MEMORANDUM FOR THE RECORD
APPLICATION# 24 IWC 7
REGULAR MEETING – THURSDAY, DECEMBER 18, 2025

Applicant: Jill Moonheron
Property Owner: Jill Moonheron
Address: 339 Chesterfield Road (Parcel ID: 021-001-00A), Oakdale, CT
Submitted: June 21, 2024
Date Received by IWC: July 18, 2024 (DRD - September 21, 2024)

SITE DEVELOPMENT PLAN
339 CHESTERFIELD RD
OAKDALE, CT

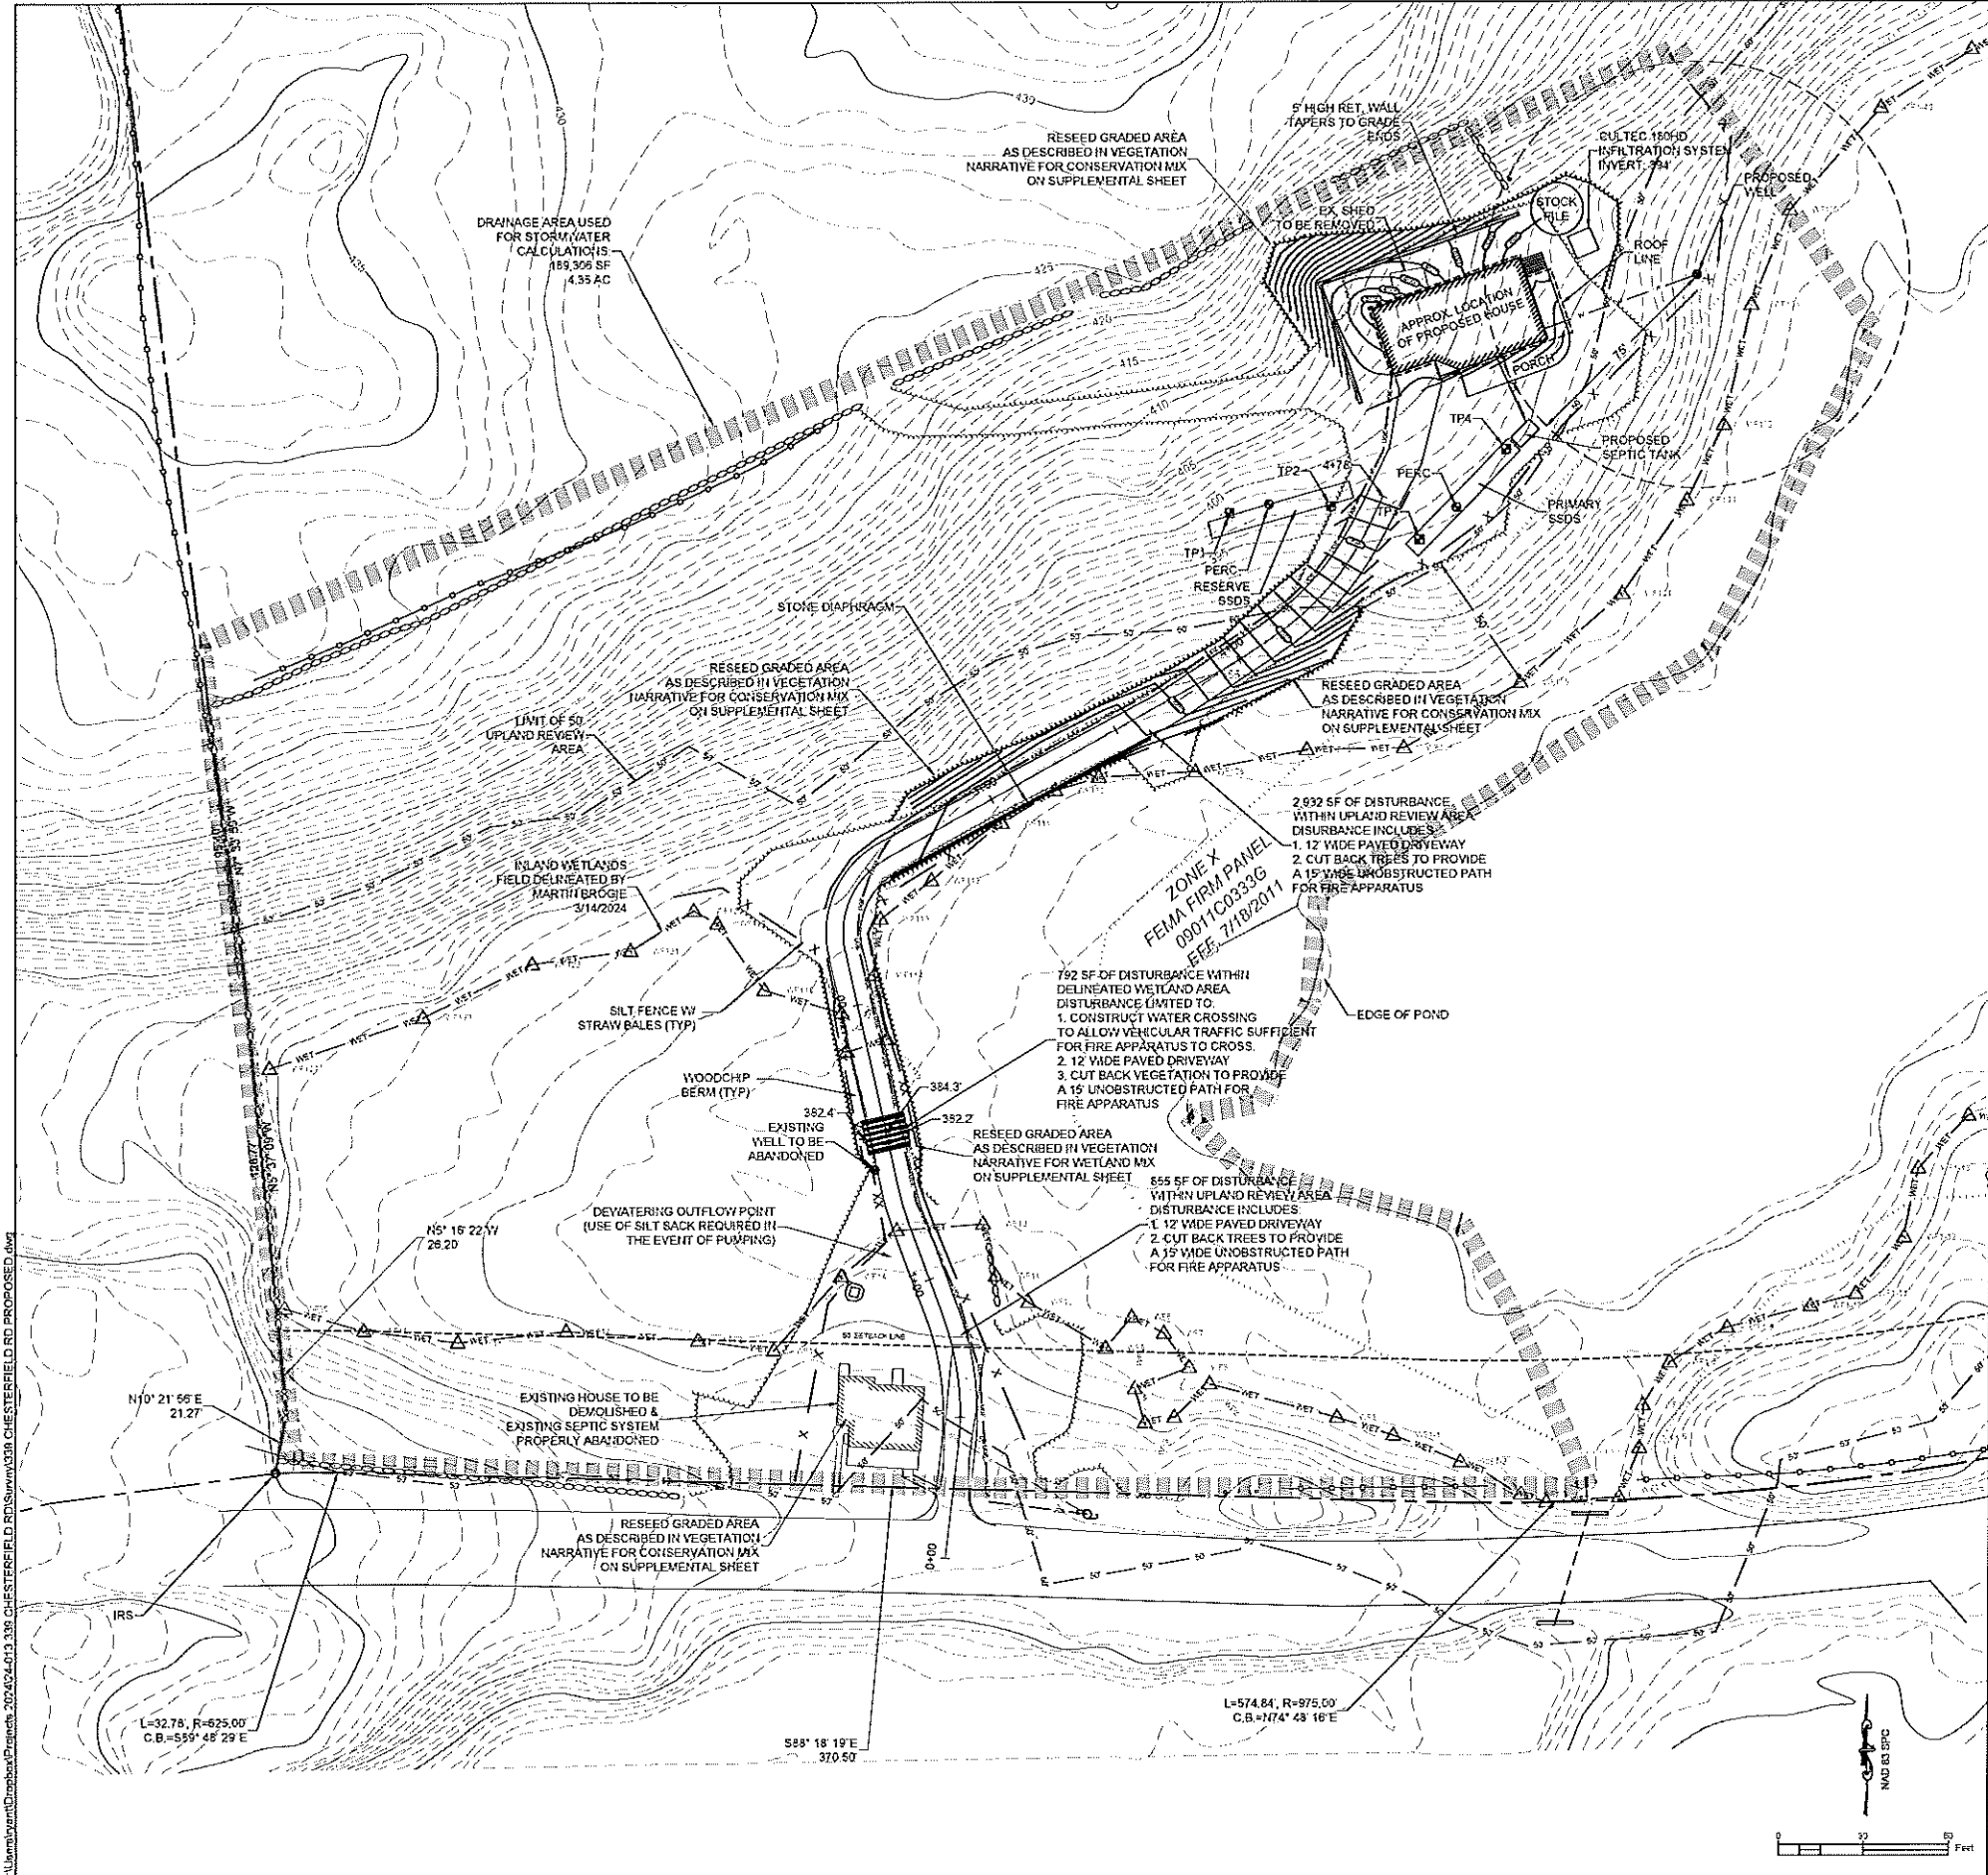
1. The stone walls along Chesterfield Road, have not resulted in wetland impacts, and they are at the outer edge of the URA.
 - The Applicant shall present a Plan for a modification of the September 19, 2024 approval, to include the installation of these walls within the URA.

2. The area disturbed by the demolition of the house was not properly re-seeded with a conservation mixture, per the approved Plan.
 - The Applicant shall have this area, and any other areas designated on the approved Plans, re-seeded in the Spring.

3. The stone walls at the wetland crossing were not shown on the approved Plan.
 - The Applicant shall have the stonewalls removed.
4. There was stone placed in the wetland at the crossing that was not on the approved Plan.

- The Applicant shall remove the stone placed in the wetlands.
5. The travel way at the wetland crossing was not constructed per the approved Plan. It is not at the proper elevation, and the travel surface is not 15 feet wide as required by zoning code and there is insufficient cover over the culverts.

6. The culvert invert elevations are off by 0.4 to 0.5 feet (too high).

- The Applicant shall have its design Engineer analyze the crossing as constructed and offer an opinion as to whether the culverts should be re-set at the proper elevation.
7. The driveway was not built per the location as shown on the approved Plan and some unpermitted wetland fill has occurred.
 - The Applicant shall provide a Wetland Restoration Plan for consideration by this Commission and ultimately remove the fill.
 8. A wetland area south of the stone diaphragm was filled without permission. The stone diaphragm was supposed to be just along the edge of the wetland with no fill in the wetland.
 - The Applicant shall provide a Wetland Restoration Plan for consideration by this Commission and ultimately remove the fill.

- The Applicant shall present a Plan for modification of the September 19, 2024 approval and have the driveway re-built in accordance with zoning codes and at the proper elevation, any alterations may further affect wetlands and require additional permitting.
